ROTHER VALLEY RAILWAY OBJ-1002-CP-7

DATE:	16 August 2021	CONFIDENTIALITY:	Public
SUBJECT:	Rother Valley Railways - review of new evidence - WATER		
PROJECT:	70047158	AUTHOR:	Chris Patmore
CHECKED:		APPROVED:

REVIEW OF FLOOD COMPENSATION OPTIONS – ADDITIONAL RVR INFORMATION SUBMITTED TO THE INQUIRY ON 13 AUGUST 2021

Figure 1: Extract from Capita drawing “Predicted Flood Depths with Railway – 1% AEP Design Flood Event with 45% allowance for climate change” annotated to show location of new compensation areas – Areas 1, 2 and 3

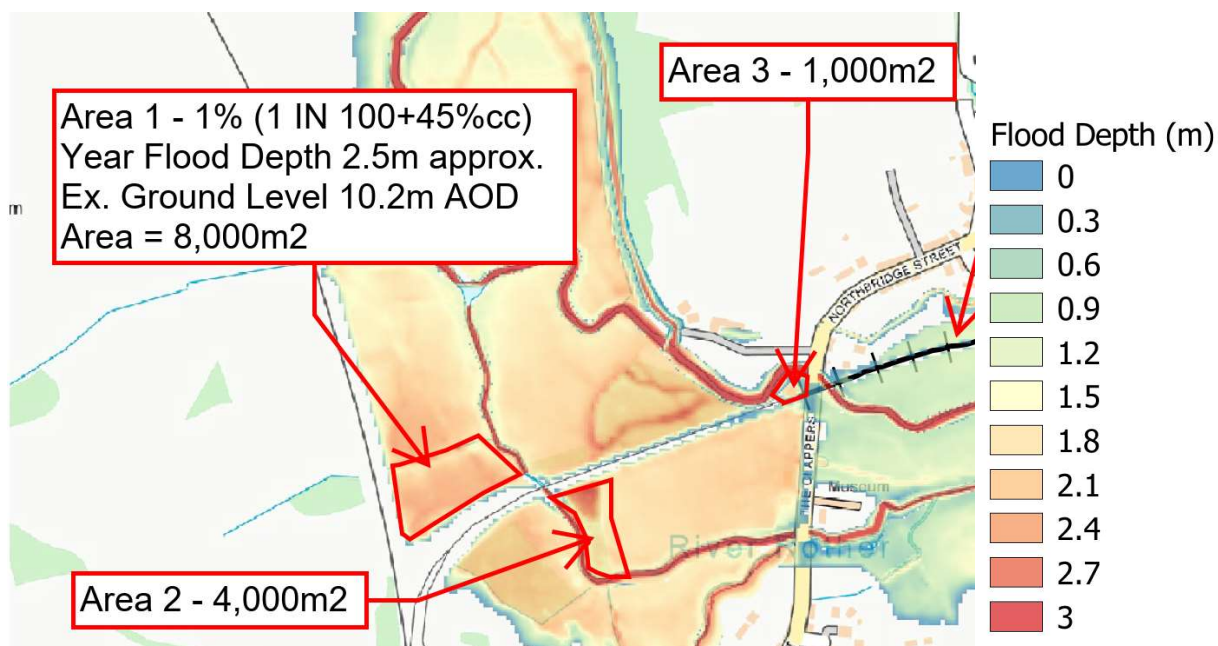
This is one of the largest compensation areas identified but is already within a modelled flood area. It is also high in the valley corridor such that the ground level is above much of the proposed track level and flood levels (particularly, the main section through Moat Farm). Track levels and existing ground levels are illustrated in Appendix A and B of this note. Mrs Callaway's notes now confirm that this area is only to deal with the new embankment to the west of A21.

Area 1 is already subject to predicted deep flooding in the 1% (1 in 100) year event with climate change (approximately 2.5m considering 45% climate change allowances) based on the Capita modelling (Appendix B and Figure 1 below). Further excavation downward would increase this depth – it is noted that this has been dismissed as an option.

Any excavation of Area 1 would also need to amend the river embankment and the public footpath that crosses the eastern edge of this area. I am not able to comment on any impact on tree planting or ecology of changes to this area.

Removing sections of the two adjacent existing railway embankments (including, significantly, a Network Rail line) could potentially undermine them structurally.

I would not consider this area able to provide all the compensation required. Some may be possible to balance out the western section of the embankment. But the location is too far up gradient to provide beneficial compensation for the section East of the A21.

This area has the same type of constraints as Area 1 but is smaller in footprint and located in Flood Zone 3b. From the Capita flood depth mapping this area is already subject to some 3m plus of flooding. This significantly impedes its ability to provide more storage

This, again, has the same type of constraints as Area 1 but is significantly smaller in footprint and also located in Flood Zone 3b. From the Capita flood depth mapping this area is already subject to between 1 and 2m of flooding. This significantly impedes its ability to provide storage

Figure 2: Extract from Capita drawing “Predicted Flood Depths with Railway – 1% AEP Design Flood Event with 45% allowance for climate change” annotated to show location of new compensation areas – Area 4

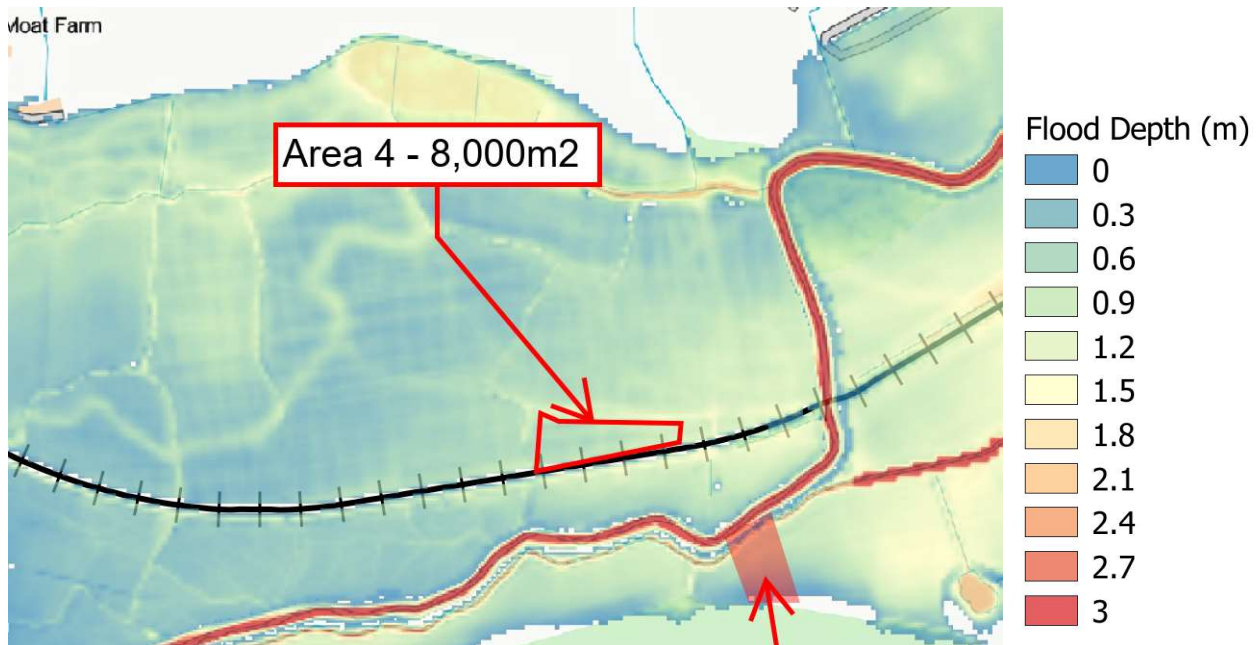
Located within Flood Zone 3b and subject to predicted flood depths of approximately 1m (Figure 2), this is a flat area that would be inundated during all flood events and is below most of the embankment levels. It may be able to provide a small amount of additional benefit to areas at the extreme eastern end of the route, but I do not consider it is capable of providing compensation for the majority of the embankment east of the A21.

Figure 3: LIDAR level data for Salehurst Halt

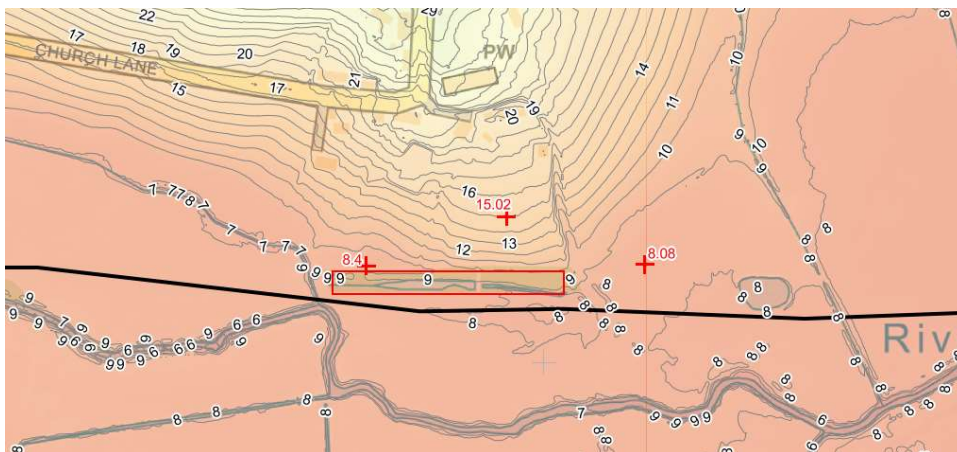
This area was mentioned within INQ/138 as a potential edge of flood plain compensation area but not in any great detail. No information is available on the extent of land being offered at the notation Figure 1 of INQ/138 only shown a line at this location. This is a liner feature (Figure 3) in an area shown to be benefiting from the addition of the railway embankment (see Figure 4 below). Although it is at similar elevations to the track levels close to this site as a result of the creation of the railway is unlikely to offer any significant volumes.

Figure 4: Extract from Capita drawing “Difference in predicted Maximum Water Level” annotated to shown location of new compensation areas

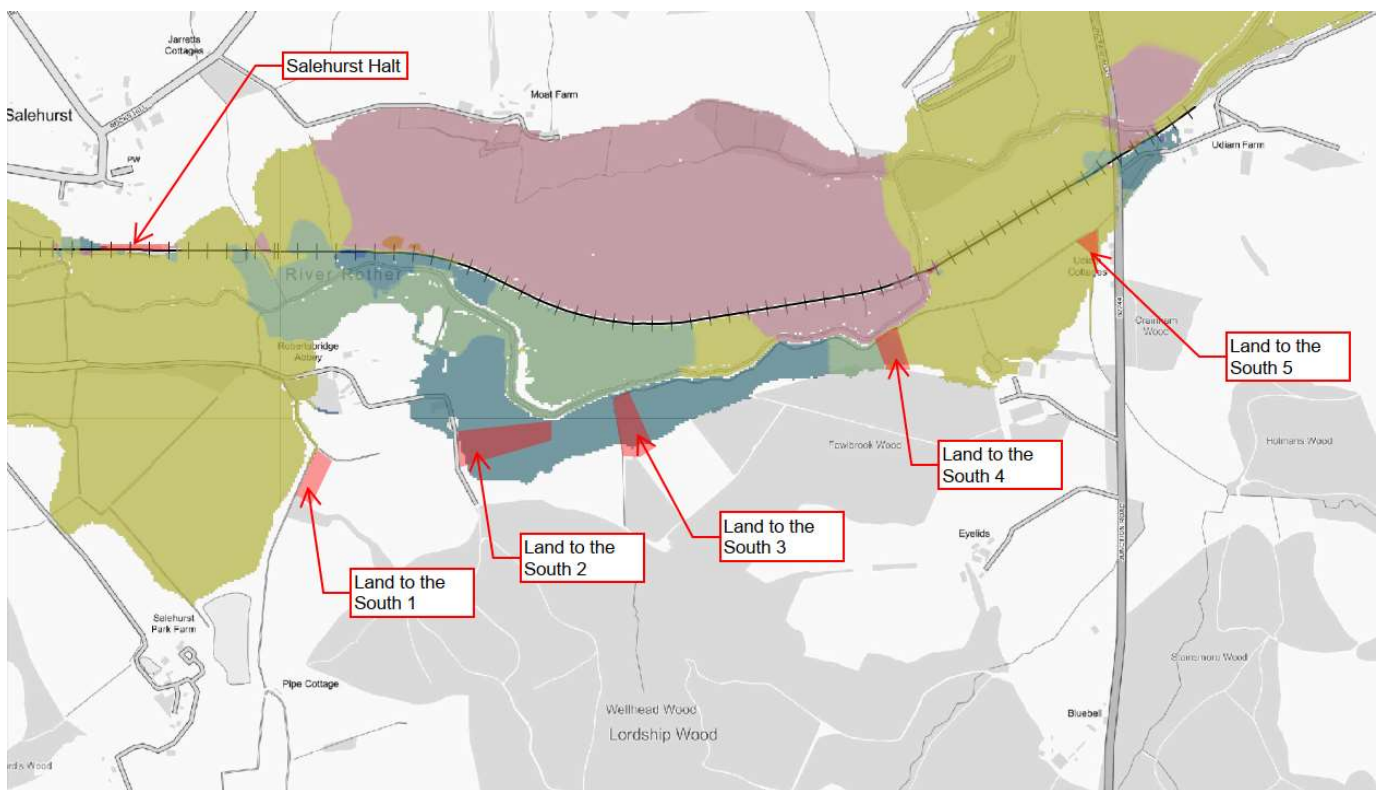
Appendix C is also attached and is an extract from Appendix B of the FRA (RVR/70-07-02) showing the difference in predicted water level mapping. This drawing shows that all the new locations (labelled Land to the South 1 to 5) are within areas predicted to benefit from the introduction of the railway embankment or areas outside the flood extents. An extract from this plan is shown below as Figure 4.

As my proof of evidence suggested was likely to be the case, these new locations are all outside the Order boundary, and outside the area covered by the planning permission. Although this is not a matter on which I am qualified to express a definitive view, it seems to me that the extraction and removal of significant volumes of earth could amount to an engineering operation for which planning permission would also be needed.

At first glance the locations shown also acknowledge that compensation should be provided at locations close to the edge of the floodplain rather than in areas that are already subject to flooding and in some cases deep flooding. These locations would be more typical of areas that should be offered for compensation.

A significant point to note is that the flood modelling has always predicted that the area to the north of the new railway embankment close to these compensation areas would be subject to deeper flooding with the area to the south benefiting from lower depths. This suggests that the modelling is predicting that with the introduction of the embankment water is being diverted to and/or is held back to the north of the new embankment.

Figure 5: Extract from Capita drawing “Predicted Flood Depths with Railway – 1% AEP Design Flood Event with 45% allowance for climate change” annotated to shown location of new compensation areas

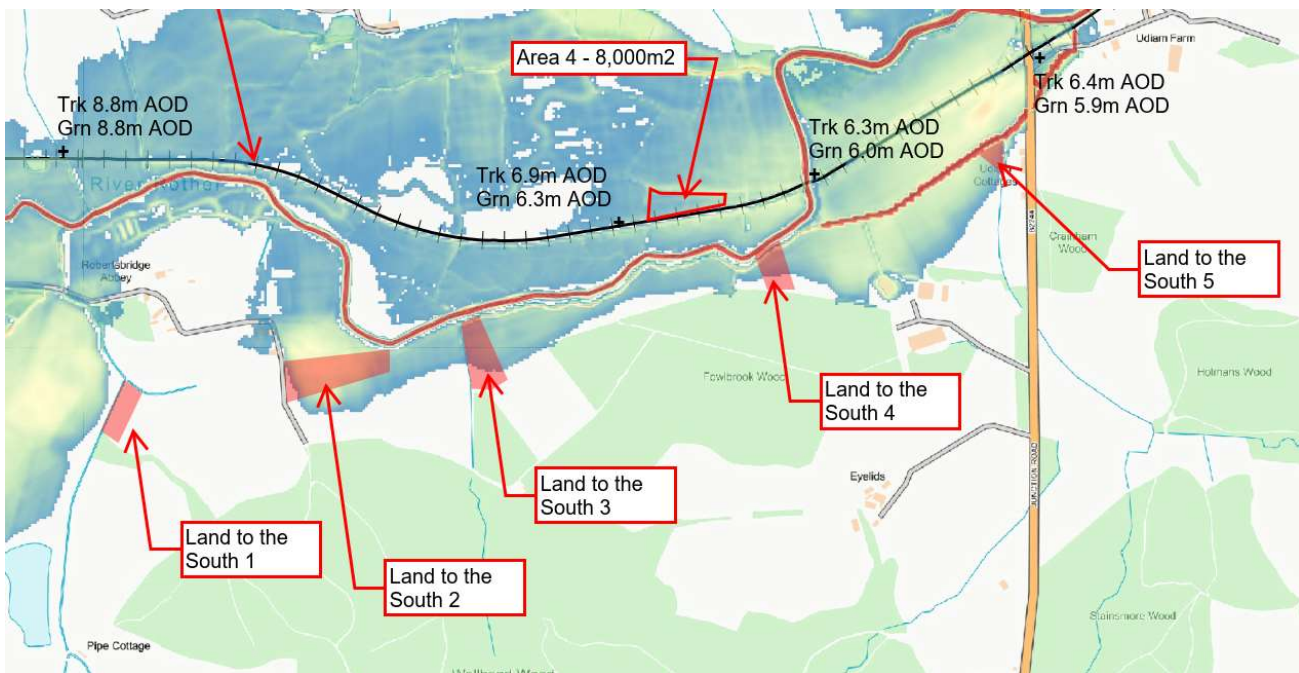
There is no detailed flow pathway analysis to demonstrate the propagation of flood waters during flood events available at present. But, as the flow is generally west to east along the Rother valley, the proposed locations of the compensation as shown would be downstream of the main impacted area (Moat Farm) with the embankment acting as a barrier between the two sides. As a result, and in advance of detailed testing, it is likely that these areas will have little if any impact on the water levels at Moat Farm. In simple terms, the sites would all appear to be on the wrong side of the embankment to provide compensation in the location where it is needed.

Figure 6: LIDAR level data for Land to the South 1

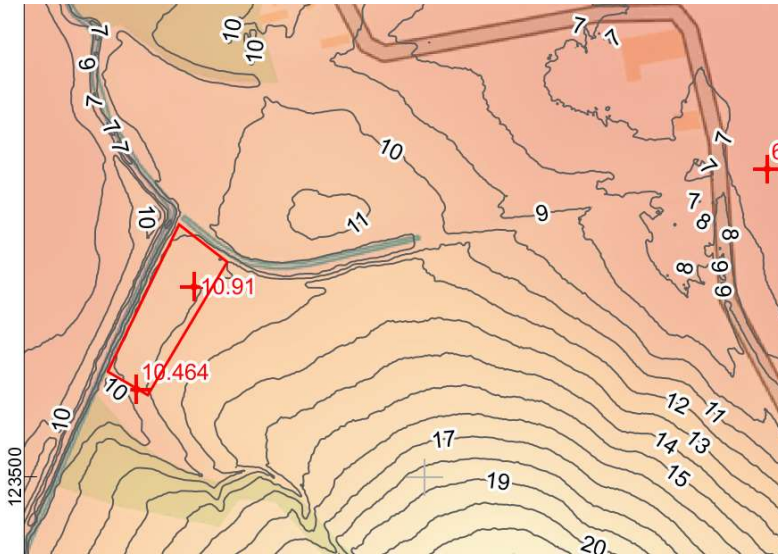
This shows the land in this area to be at elevations of between 10.46 and 10.91m AOD. Reference to the embankment levels (Appendix A) shows that without extensive excavation this area would only be able to address the higher embankments to the west of A21.

The elevation of the land is also evident when reviewing against the predicted flood mapping produced by Capita. For compensation to be functional it has to be hydraulically connected directly to the existing flood extents. This area is potentially linked to the flooded areas by the watercourses to the north and west. Without detailed topography it is not possible to determine if these features are sufficiently deep to allow flood waters to reach this compensation area.

From mapping provided in INQ/149, this land is at the extreme western end of “Lot 3”. As such it is not clear if the landowner offering this land has control over the watercourse should any modifications be required to enable the free flow of flood waters at appropriate depths.

Figure 7: LIDAR level data for Land to the South 2

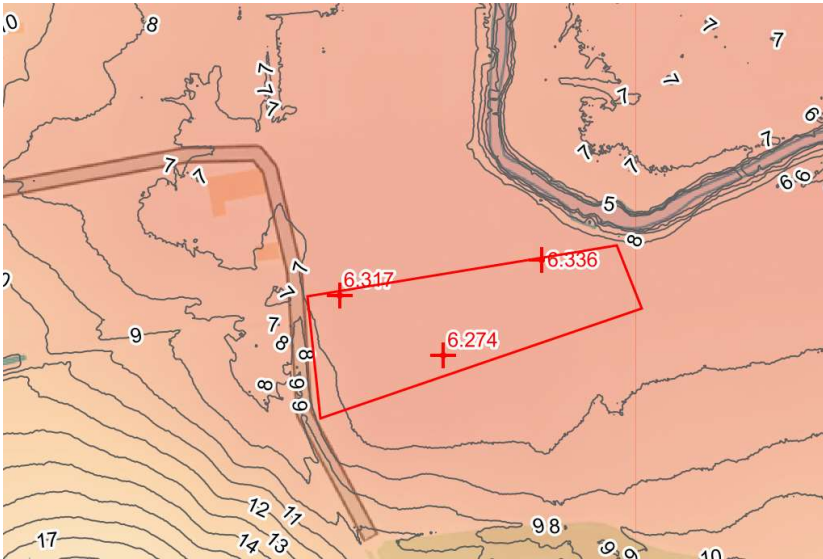
Figure 7 shows the land in this area to be at elevations of between 6.27 and 6.34m AOD. With reference to the embankment levels (Appendix A) this may be able to offer some compensation for the extreme eastern end of the railway embankment.

I would suggest that this area offers very little opportunity for acting as an area of compensation.

Figure 8: Extract from Google maps for Land to the South 2 (extracted 19th August 2021)

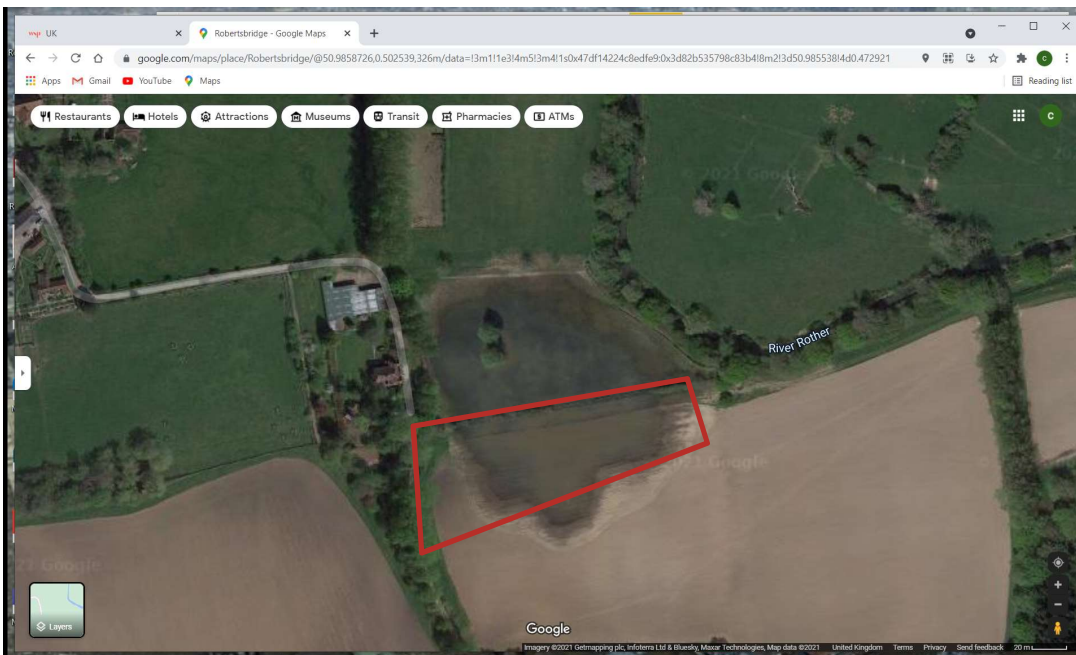
However, it should be noted that with reference to the Google Map imagery (Figure 8) it is clear that this area is susceptible to waterlogging and frequent flooding already. Below is an extract from the current aerial photography with an image taken in 2021 showing this area to be flooded (note that a wider view of the site shows this to be one of only a few areas shown waterlogged).

Figure 9: LIDAR level data for Land to the South 3

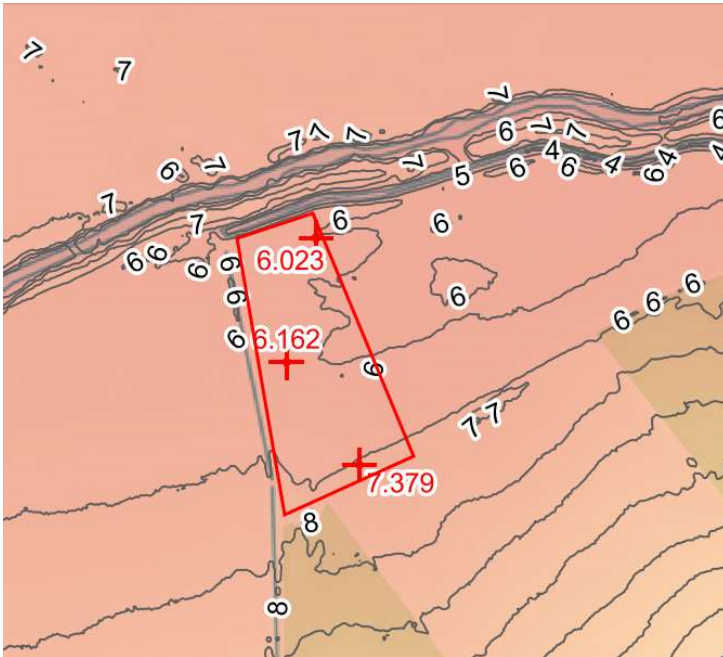
This site is partially within the flood zones and partially outside. This would be a typical compensation arrangement. It is possible that the southern edge of this area may be able to provide some compensation volume as the land rises.

Figure 10: LIDAR level data for Land to the South 4

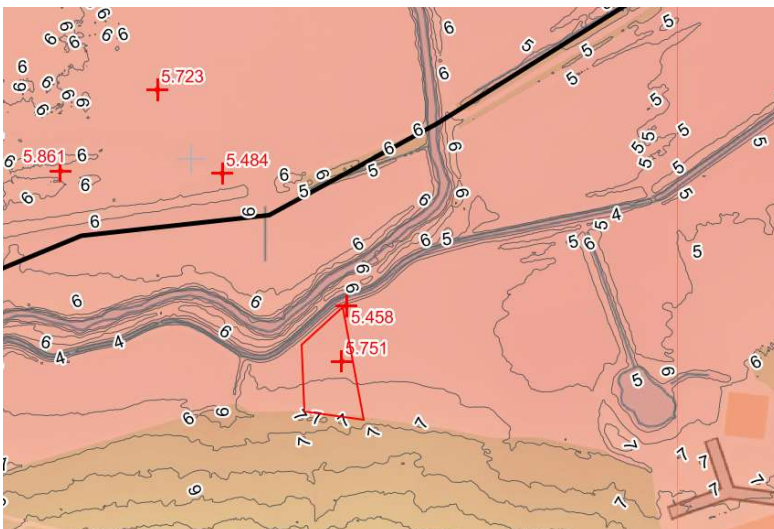
This site is also partially within the flood zones and partially outside. This would be a typical compensation arrangement. Although smaller than site 3, it is possible that the southern edge of this area may be able to provide some element of compensation volume as the land rises.

Figure 11: LIDAR level data for Land to the South 5

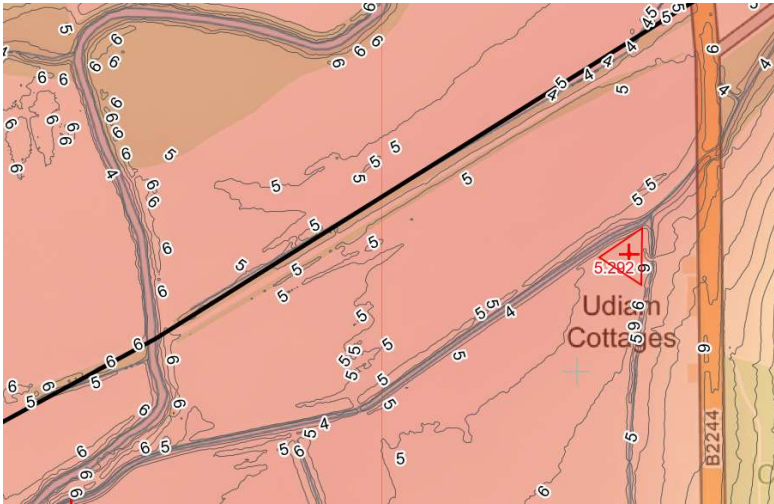
This is the smallest of the sites is totally within the flood zones. Due to its location in the flood plain, its elevations which are at the lowest point of the route (levels below the lowest ground level along the route) and its relative size, this site will offer little in the way of storage compensation volume.
